## Safety Recall Action Notice 584 Issue 2 - 10.2020

Subject: VIN Label Protector Fitment			
Bulletin Number	Models Affected	VIN Range	Markets Affected
584	Street Scrambler	From VIN 914448 to VIN AC6893	All Markets Except China
584	Street Twin	From VIN 914973 to VIN AC6893	All Markets Except China

1. Lock nut
2. VIN label protector
3. Flanged sleeve
4. Screw

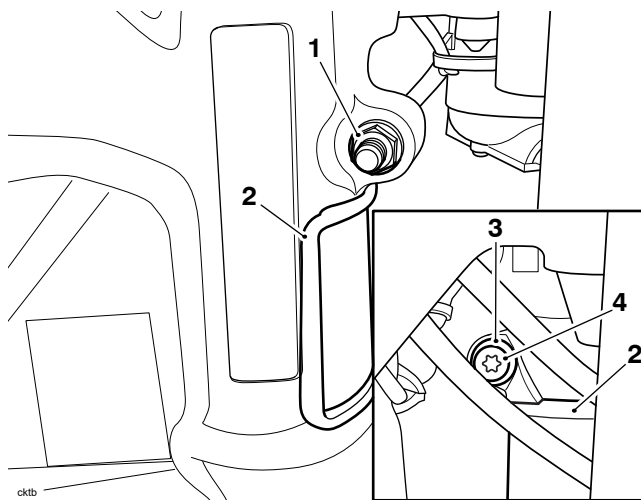
1. Turn the handle bars to the left to allow access to the VIN label protector fixings.
2. Remove the lock nut, flanged sleeve and screw and remove the VIN label protector from the motorcycle. Discard the lock nut and VIN label protector.

3. Align the new VIN label protector to the frame as shown. Fit the flanged sleeve, screw and new lock nut to the VIN label protector and tighten the screw to **3 Nm** whilst holding the lock nut.

1. Ignition branch (switch housing branch behind, not shown)
2. Headlight branch
3. DRL branch
4. Instruments branch

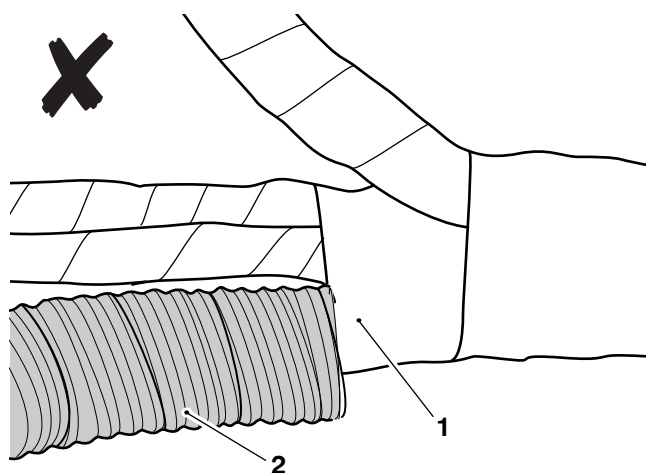
12. Check the orientation of the harness. The switch housing branch should sit behind the ignition branch and the headlight and DRL branches should be situated above. The DRL branch should be inboard of the headlight branch. The instrument branch should be situated above as shown in the illustration below.

Graphic showing incorrect taping of ignition branch conduit

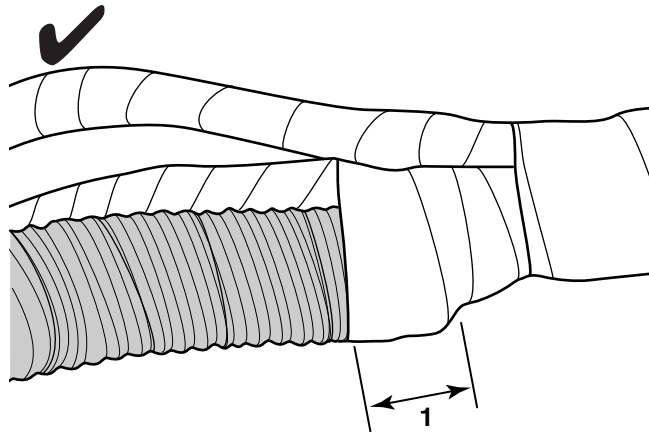
13. Check the ignition branch conduit has been correctly taped. The tape covering the four branches (Ignition branch, Switch Housing branch, Headlight branch and DRL branch) should overlap the ignition branch conduit by 10 - 15 mm.

14. If the ignition branch conduit taping is incorrect, apply tape to all four branches forward of the instruments branch. The tape should be overlapped by at least 10 mm working forward until the ignition branch conduit is overtaped by 10-15 mm as in the illustration above.
15. If the ignition branch conduit taping is correct or has been corrected, continue from the next step.
16. Lift the headlight and DRL branches upwards and apply tape across the ignition and switch housing branches. The tape should wrap round at least twice, be one tape width wide, with the tape squarely aligned with itself.
